**Re: Modification to Residential and Open Space Development, Former Rachel Forster Hospital,
 134-144 Pitt Street, Redfern (MP 07_0029 MOD 1 and MP 09_0068 MOD 1).**

Weir Phillips Heritage have been asked to address the heritage issues outlined in 'Schedule 1-Key Issues' of the above letter. These are as follows:

Figure 2: Revised elevation for Building C.
Tony Owen and Partners (detail).

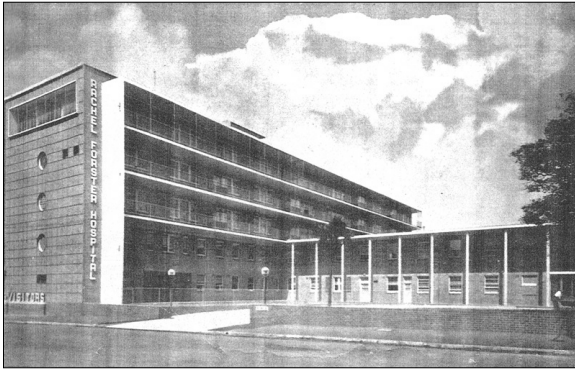
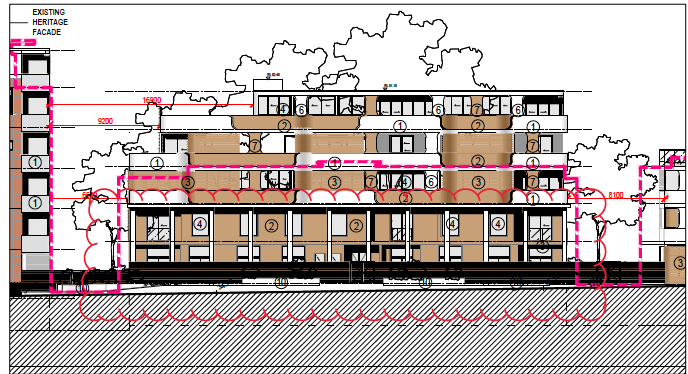
The additional proposed storey to Building 3 will relegate the colonnade to a secondary element in the façade and thus have an adverse impact on the setting and spatial presentation of the colonnade; and

The proposed material will have a negative impact on the colonnade

Whilst the proposed height is retained, the design of the eastern elevation has been amended to address these concerns in the following ways:

- The size of window and door openings has been reduced. This provides a solid to void ratio more in keeping with the original pattern of openings behind the colonnade, which, in turn, makes the elevation more recessive against the colonnade.
- The architectural elements and finishes of the elevation behind the balustrade have been modified. The white balustrades and timber screens originally proposed at ground and first floor levels have been removed. The material palette is now more recessive against the rendered white masonry of the columns.

As demonstrated by a comparison of Figure 1 (a historic photograph of the original eastern elevation of Building C) and Figure 2 (a detail of the revised plan for the new elevation-below), the revised plan provides a good interpretation of the original elevation. The effect of this is as follows:

Figure 3: Detail of the accompanying plans showing the approved building line (in pink) and the proposed building line.

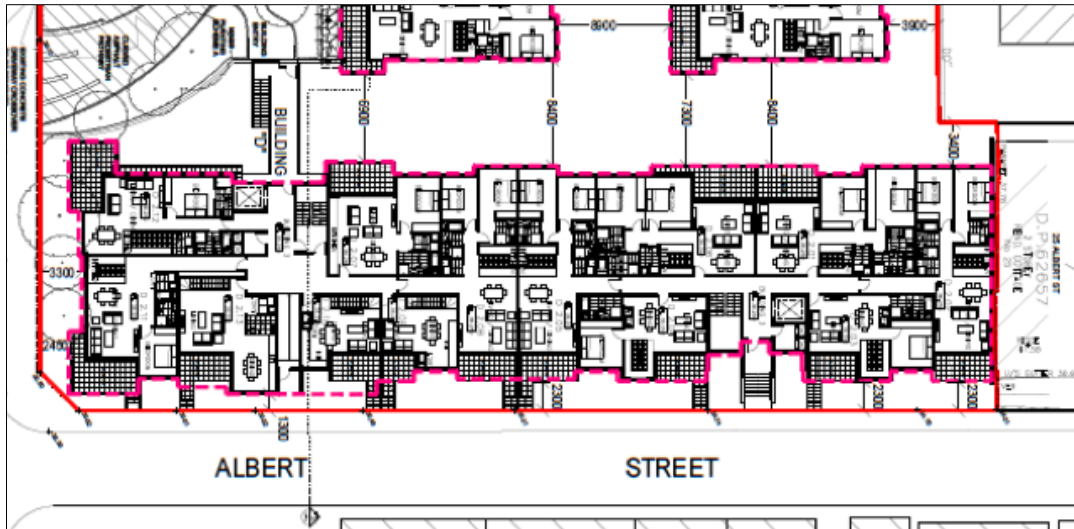
- *The proposal is located forward of the principal building to the west.*

Figure 3 shows that the western end of the proposed building is located no further forward than the approved building.

Figure 4: Detail from the approved Albert Street elevation, showing approved 1.5m high fence to Albert Street.

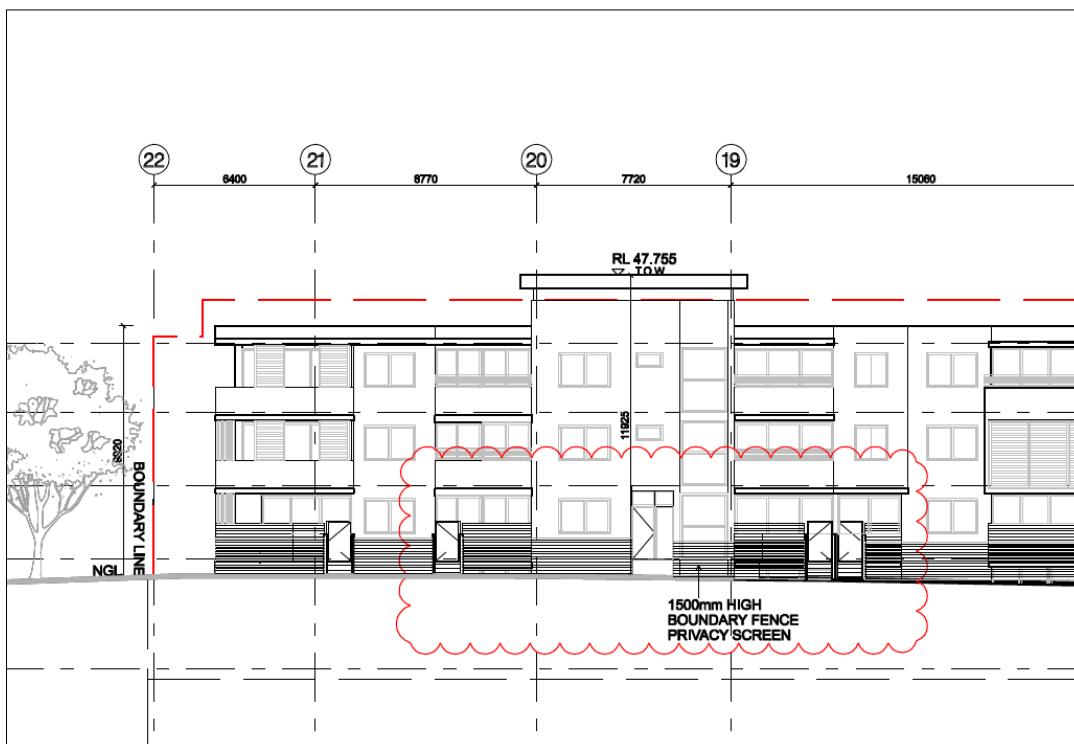
- *The front fence is higher than the existing houses in the street.*

The approved fence height is 1.5m. The proposed fence height is 1.5m. Refer to Figure 4.
